**Economic Commission for Europe****Inland Transport Committee****World Forum for Harmonization of Vehicle Regulations****Working Party on Lighting and Light-Signalling****Eighty-third session**

**Other UN Regulations:****UN Regulation No. 86 (Installation of lighting and light-signalling devices for agricultural vehicles)****Proposal for a draft amendment to UN Regulation No. 86****Submitted by the experts from the European Agricultural Machinery Association\***

The text reproduced below was prepared by the experts from the European Agricultural Machinery Association (CEMA) with the aim to improve lateral lighting on vehicles of more than 4,6 m and to take into account asymmetric vehicles designs. It intends also to provide some editorial corrections and to harmonize some requirements with UN Regulation No. 48. The modifications to the current text of the Regulation are marked in bold for new or strikethrough for deleted characters.

Figure 1

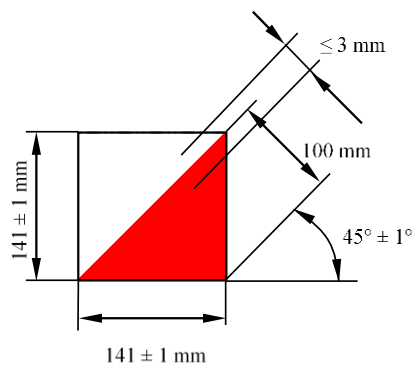
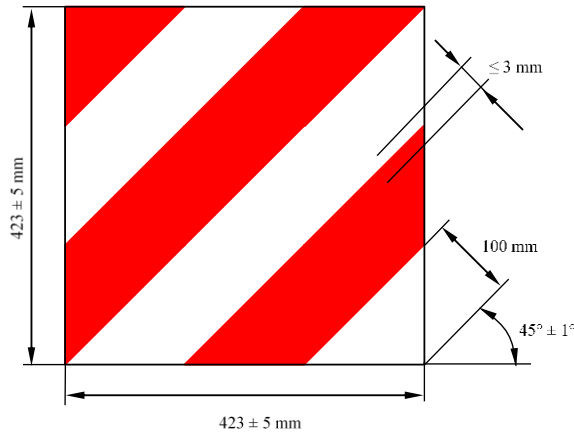
Annex 6, Paragraph 1.1, amend to read:

"1.1. Signalling panels and signalling foils shall have the following dimensions:"

Signalling panel or signalling foil	<i>a</i> [mm]	<i>b</i> [mm]	Surface [cm <sup>2</sup> ]
Form A	423 ± 5	423 ± 5	≥ 1,790
Form B	282 ± 5	282 ± 5	≥ 795
Form R1	282 ± 5	423 ± 5	≥ 1,193
Form R2	423 ± 5	282 ± 5	
Form L1	141 ± 5	846 ± 5	≥ 1,193
Form L2	846 ± 5	141 ± 5	
Form K1	141 ± 5	423 ± 5	≥ 596
Form K2	423 ± 5	141 ± 5
